Surface water responses

16 February 2021

**Re: Cowal Gold Operations Underground Mine Project Hydrological Assessment –
Response to DPIE Water and NRAR Comments**

Figure 1 Predicted Annual Bland Creek Palaeochannel Borefield Usage (refer Figure 19 of Appendix G of the EIS)

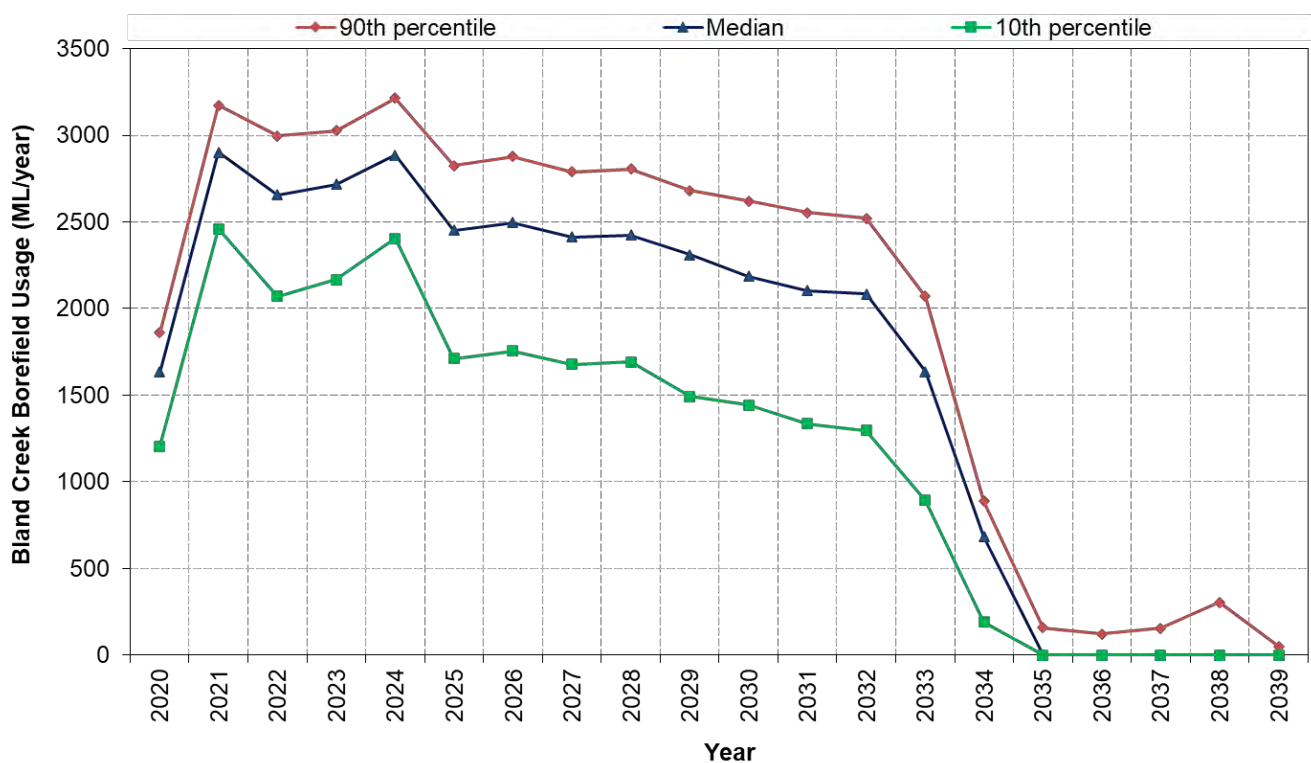
“90th percentile rainfall sequence (Dry) annual demand from the Bland Creek Paleochannel Bores to be approximately 3,700 ML/year (in year 2022). The proponent currently holds a licence with an entitlement of 3,650 ML/year” (DPIE Water and NRAR, 2021).

Figure 19 of Appendix G of the EIS (refer Figure 1 below) presents the water balance simulated 10th percentile, median and 90th percentile annual water demand / usage from the Bland Creek Paleochannel Bores. The 90th percentile annual volume is the demand / usage that was predicted not to be exceeded in 90% of the simulated 131 climatic sequences and the 10th percentile annual volume is the demand / usage that was predicted not to be exceeded in 10% of the simulated 131 climatic sequences. The percentile plots indicate predicted annual volume ranges between the 10th and 90th percentile risk or confidence limits / levels within which the predicted annual volumes could vary. The 90th percentile annual demand does not represent the annual demand / usage for the 90th percentile rainfall sequence, rather the 90th percentile annual demand / usage based on all 131 climatic sequences (model realizations) simulated. This is stated in the second paragraph of Section 6.2.2 of Appendix G of the EIS.

Figure 1 (Figure 19 of Appendix G of the EIS) illustrates that the annual demand from the Bland Creek Paleochannel Borefield is predicted to peak at 3,215 ML in 2024 based on the 90th percentile model results (calculated from all 131 simulated climatic sequences) and at 2,901 ML/year in 2024 based on the median model results (calculated from all 131 simulated climatic sequences). These annual volumes do not exceed the 3,650 ML/y held by the proponent.
